## **ADDENDUM**

**PROJECT:** Forestside Estates  
Attmar & Palleschi Drive  
Brampton, Ontario

**PROJECT NO.:** 18-017

**ADDENDUM NO.** E-3

TITLE  
**3RD FLOOR PLAN  
ELECTRICAL**

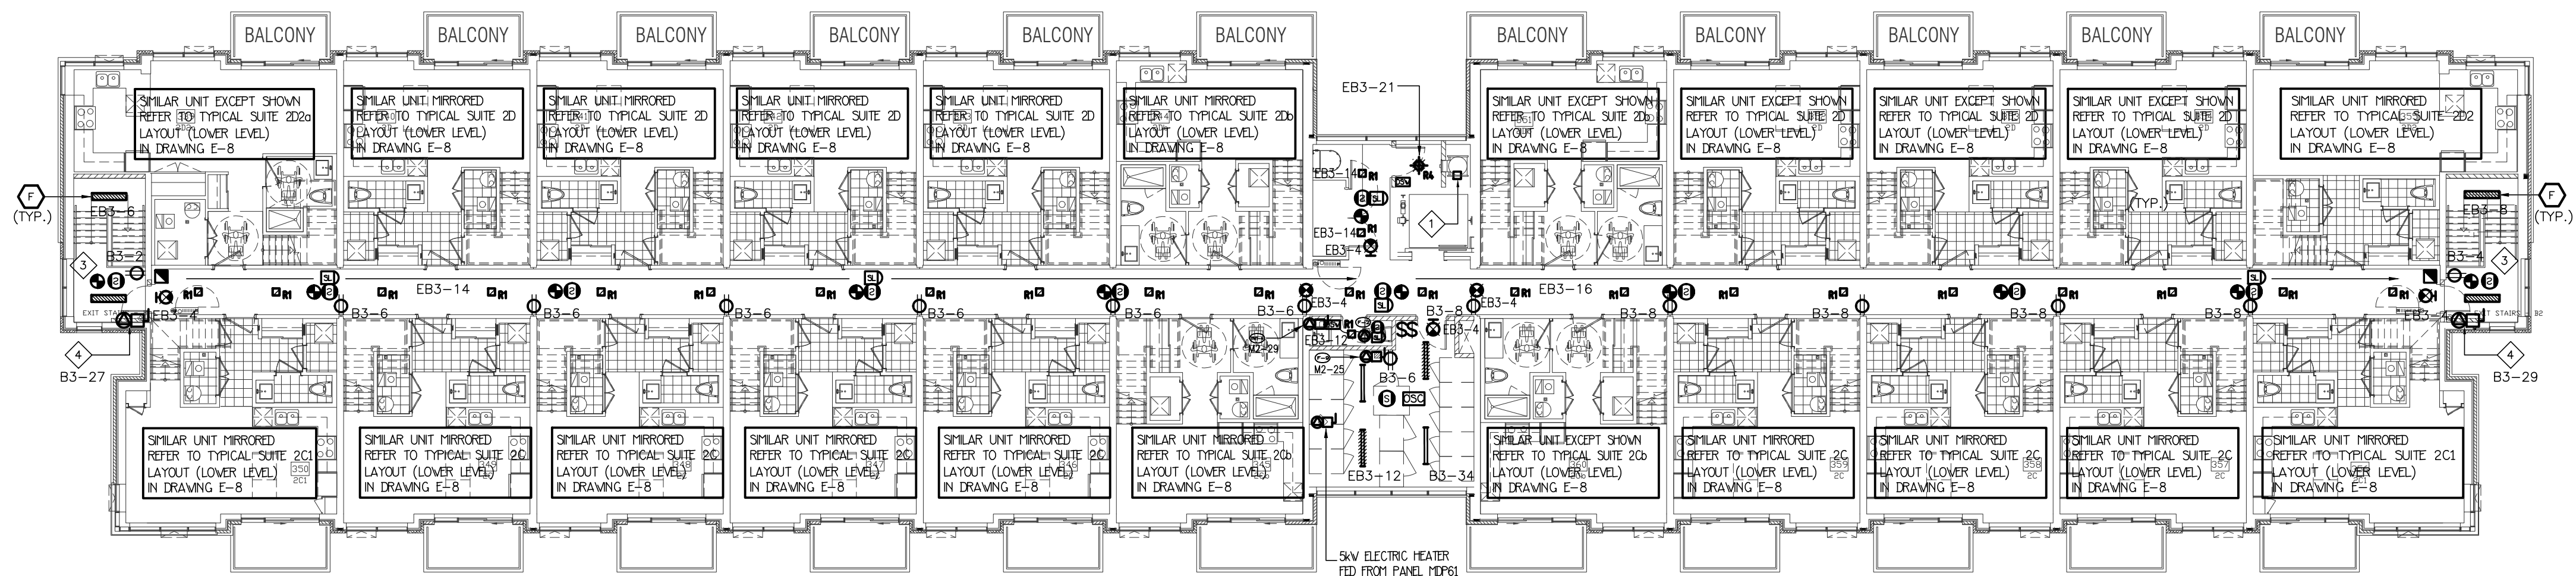
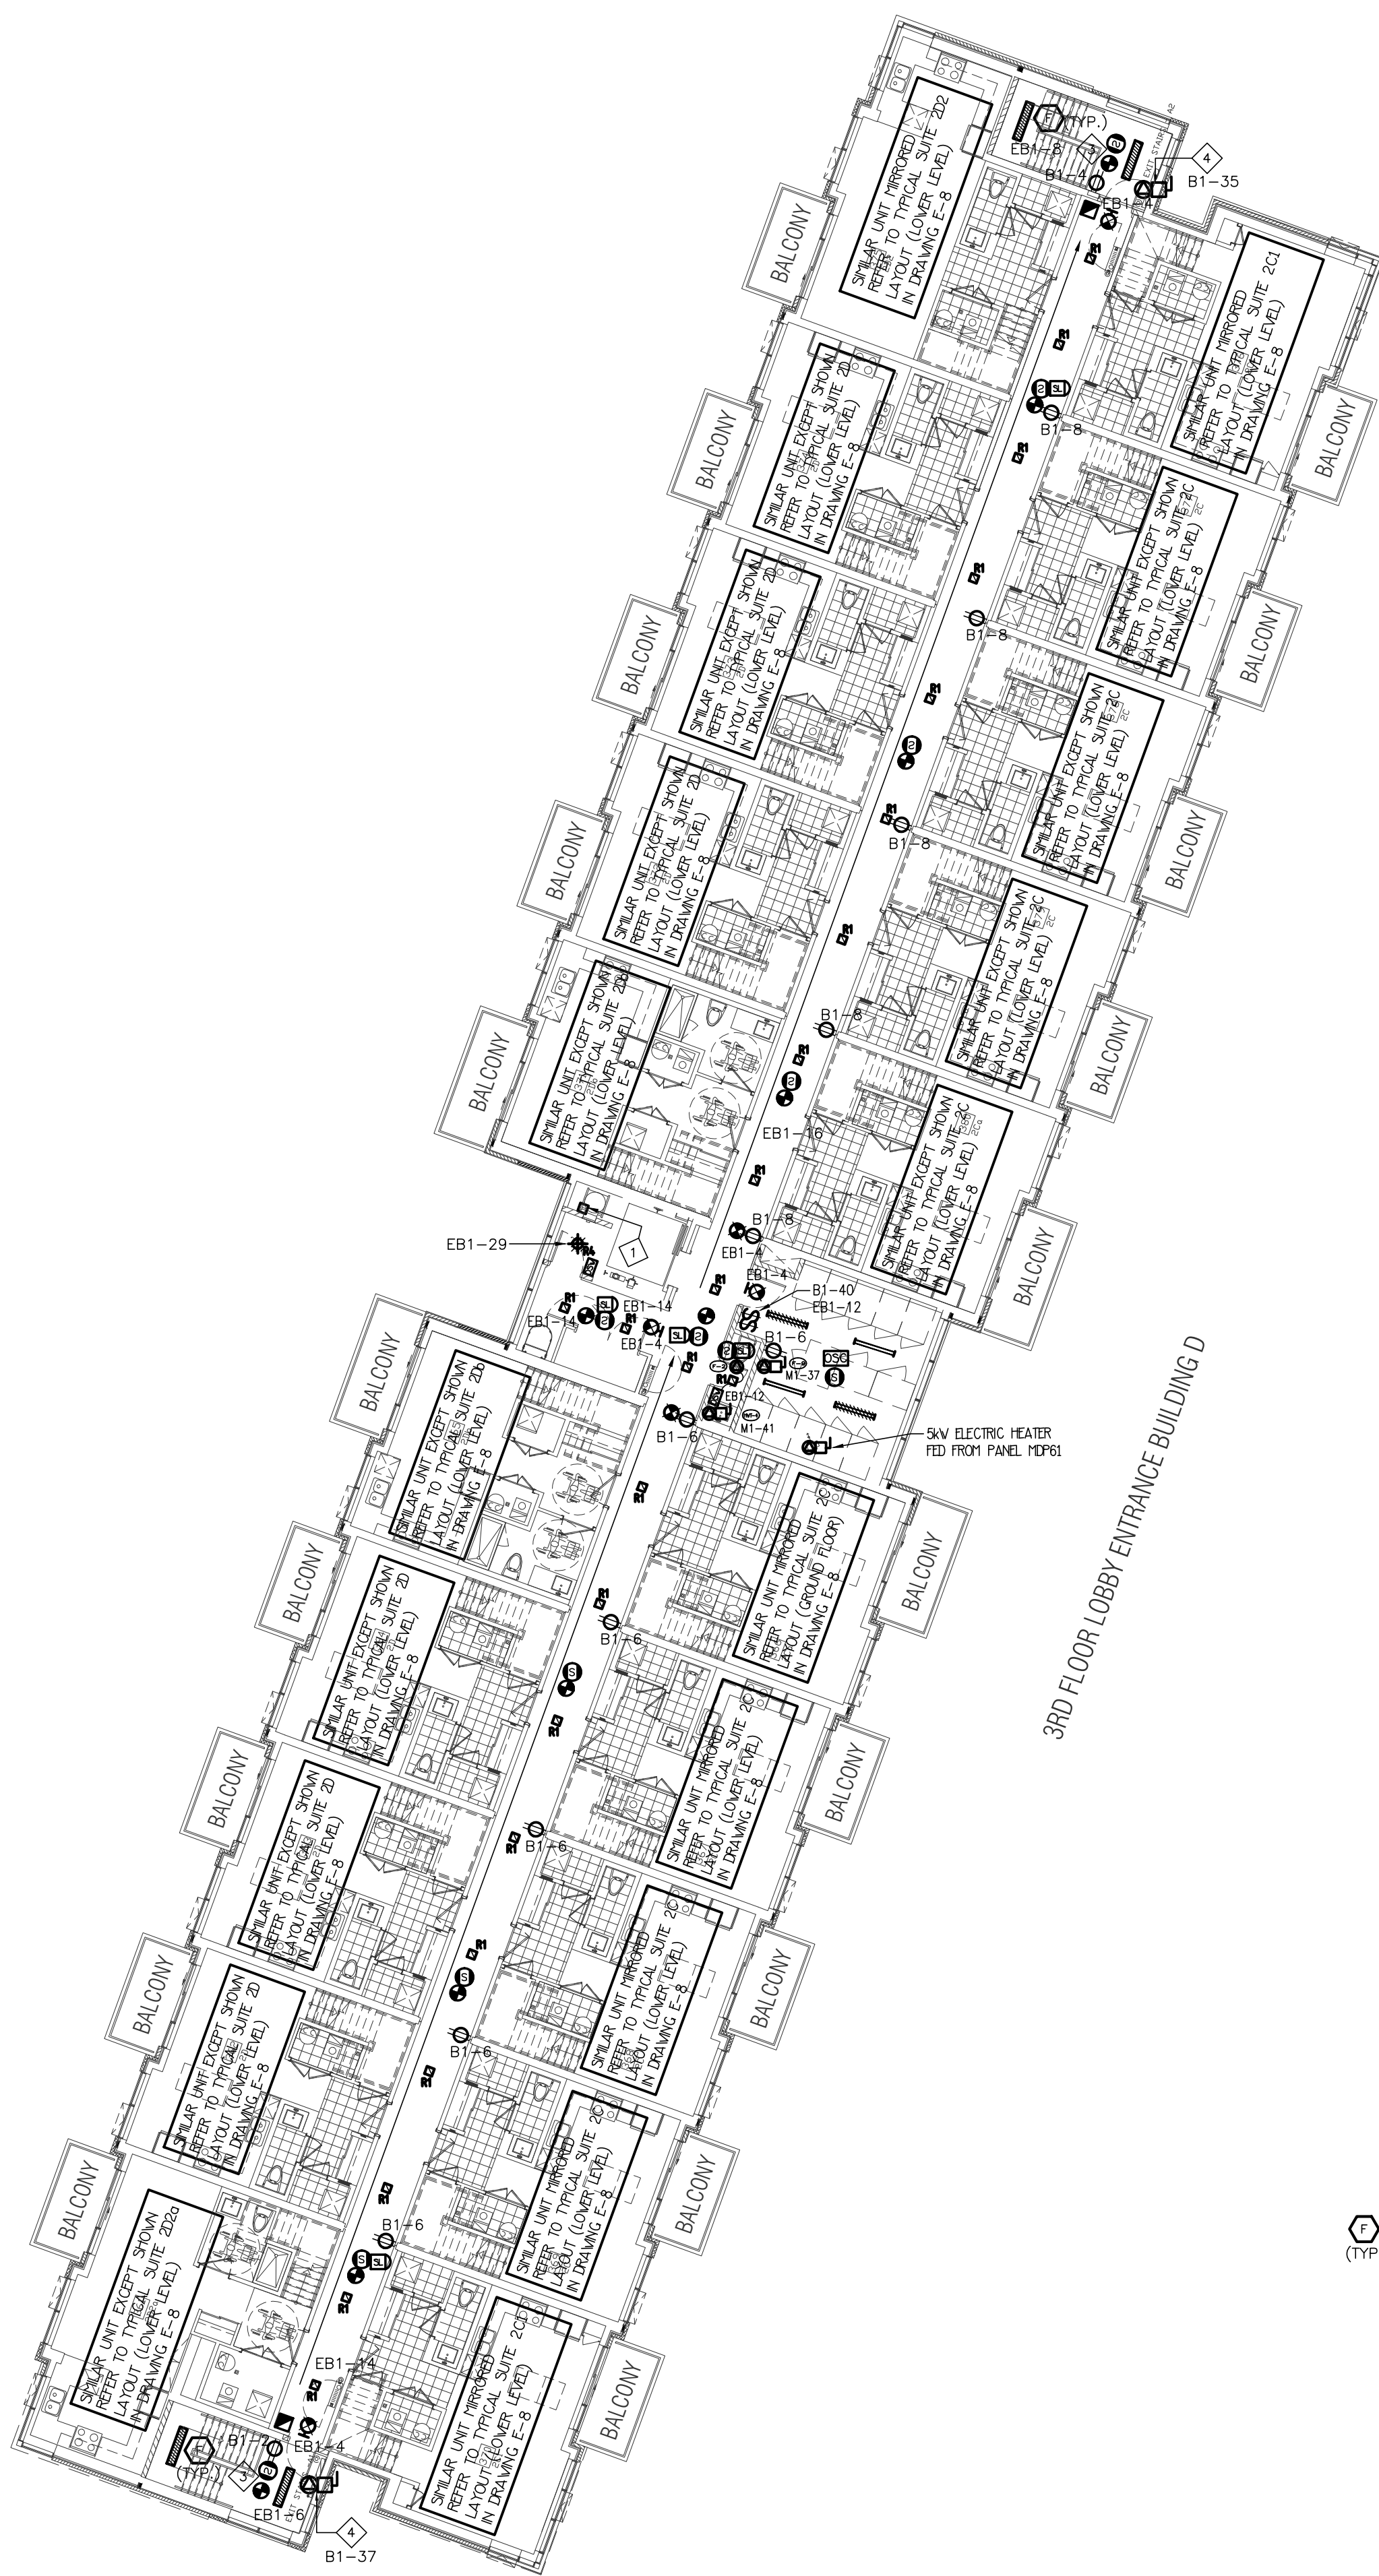
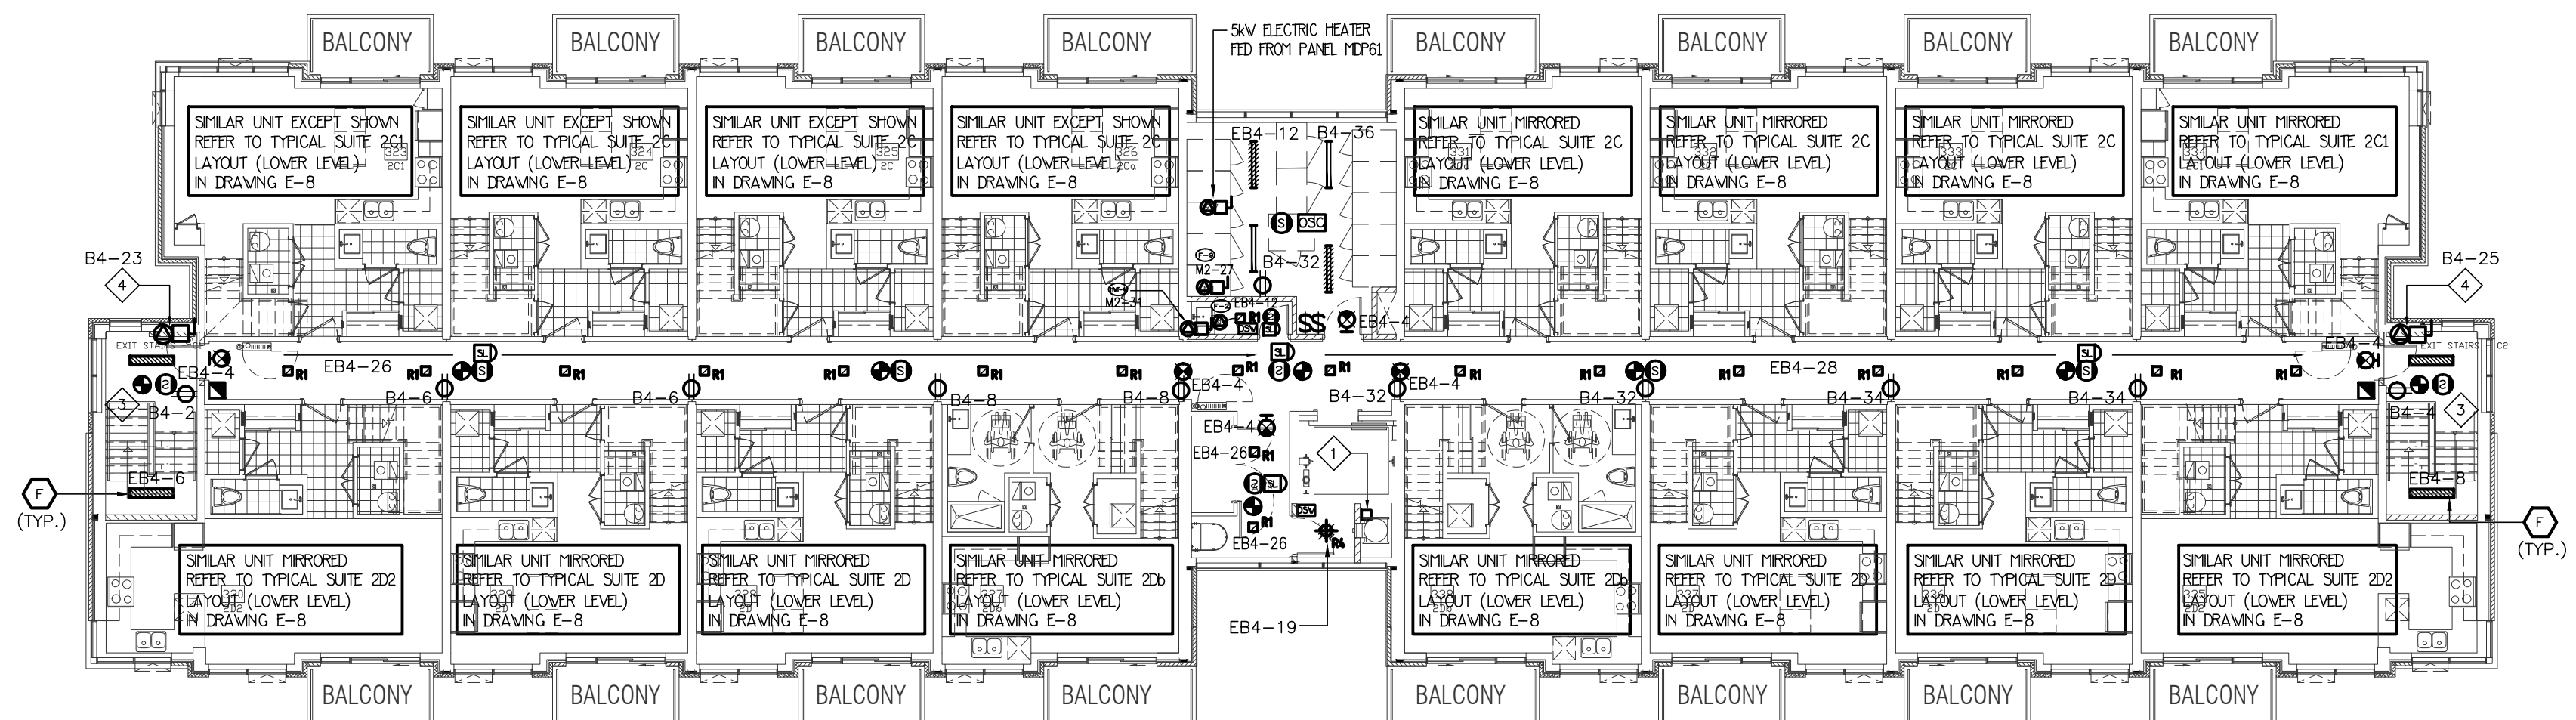
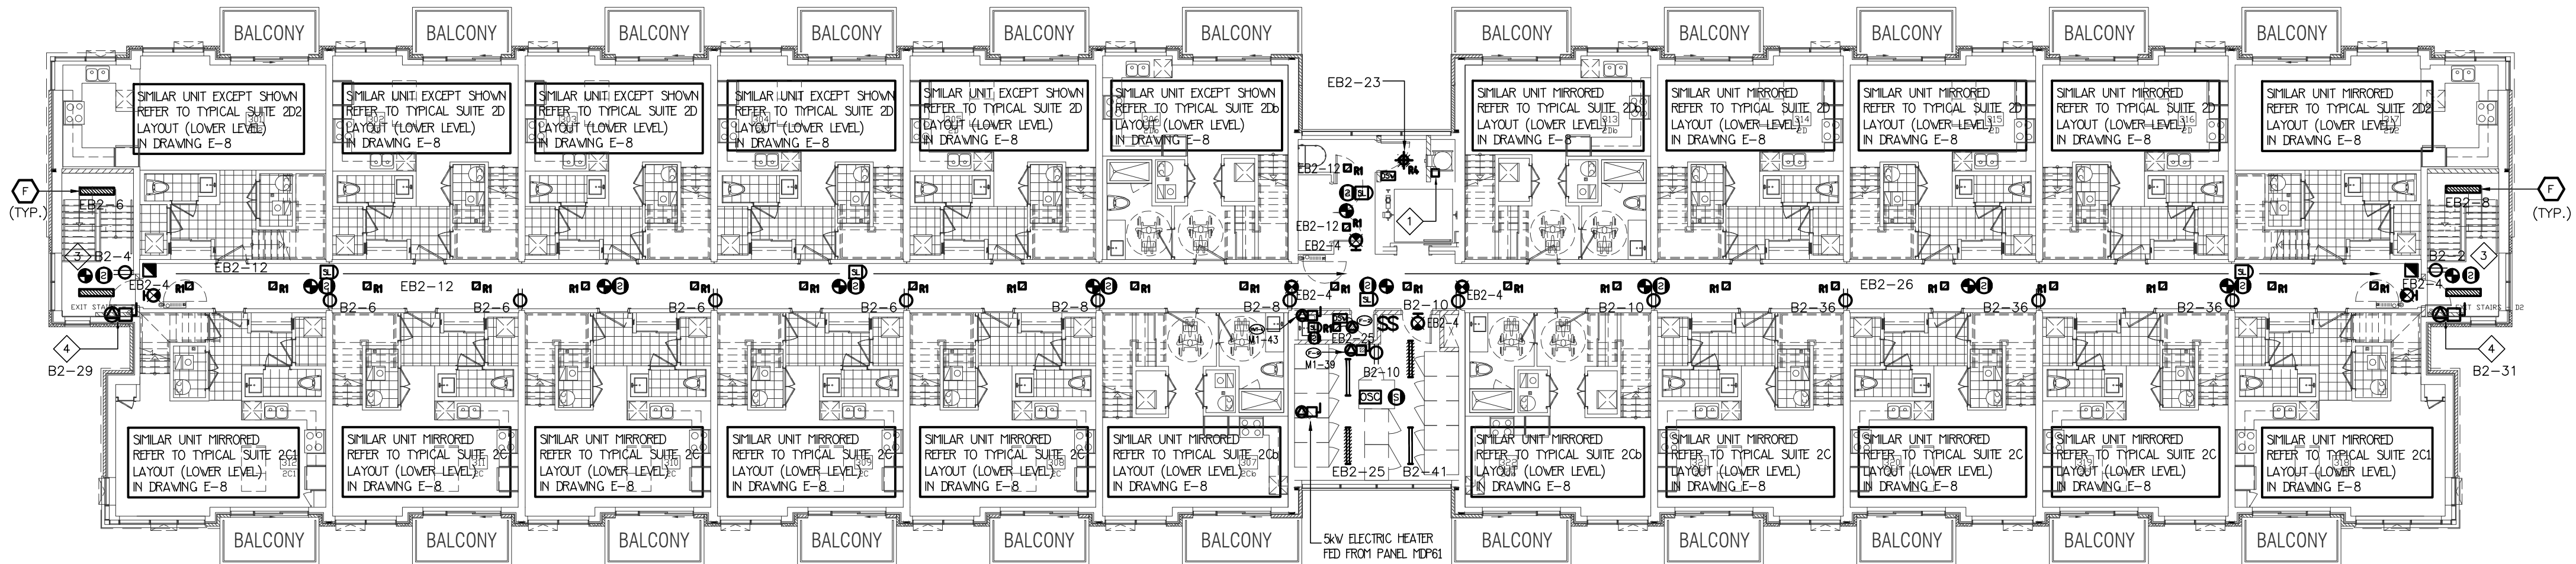
**2.0 Reference Drawings E-3 (Ground Floor - Electrical) Issued**  
**E-4 (2<sup>nd</sup> Floor- Electrical)**  
**E-5 (3<sup>rd</sup> Floor- Electrical)**  
**E-6 (4<sup>th</sup> Floor- Electrical)**  
**E-7 (Roof- Electrical)**

2.1 Revise: Unit type for building C block 6 to suit latest arch drawings as shown

2.2 Revise: Unit numbering to suit latest arch drawings as shown
